Service Information Letter

Notification of Product Improvement for 4C3500 High Voltage Frequency Converters

SIL 24-20-02

Figure 1 Bridge Assembly

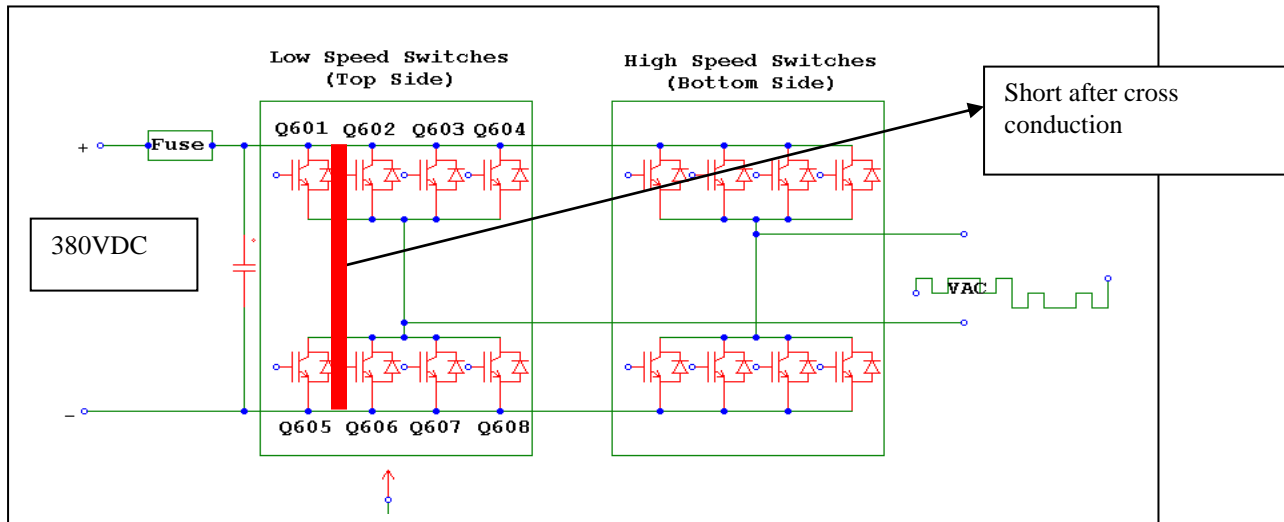
Simultaneous conduction of upper & lower Low Speed Switches could result in a short circuit across the 380v DC Link voltage bus. See Figure 1 illustrating this "cross conduction event". Instantaneous power dissipation on these switches would then be excessive, exceeding the device rating. As a result unrepairable damage to the power pc board may occur, e.g., Power PC Board burnt or discolored, as well as other assemblies that are in close proximity to the power board.

To prevent high levels of damage to the power boards and the control board of the frequency converters, Avionic Instruments is upgrading the above units to Mod "J". This product improvement adds fast acting fuses for Fuse (F1) to 30A (3 10A fuses / P/N 1-001-0814-0009) which replaces the 30A single fuse which is currently being used as this enables the fuse to react more quickly to prevent damage.

Engineering testing was done with the fast acting fuses by simulating a bridge failure and the fuses opened-up before any damage to PCB's occurred. An ECN will be generated to change the fuse configuration. If there is a failure on the bridge assembly the fuse will open, removing power to the bridge and preventing further damage to PCB's.

Figure 2
Fuse Configuration

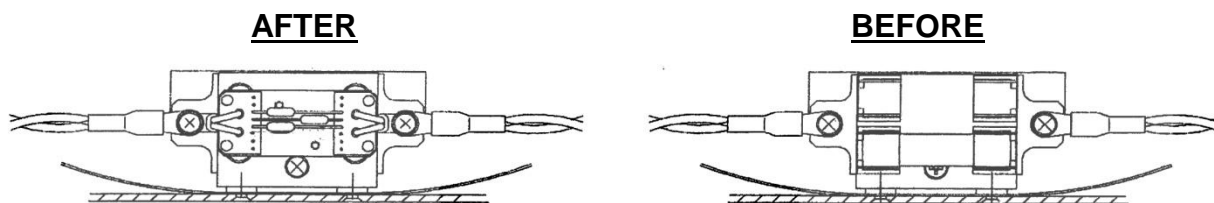
Avionic Instruments has released this SIL to alert the fleet operators in possession of the in-service frequency converters of the potential for product improvement. This SIL contains information on a change to the fuse configuration for the frequency converters cited herein. The 30 amp fuse is being replaced with three 10 amp fuses. The modified converters will be identified as "MOD J". See Figure 2 for the before and after fuse configuration.

Delete from High Voltage type Chassis assemblies the sub assembly P/N 1-002-0113-0642 (FUSE BRACKET ASS'Y) and replace it with new assigned P/N 1-002-0113-1067 (new release...Rev-A).

End result of executing product improvement
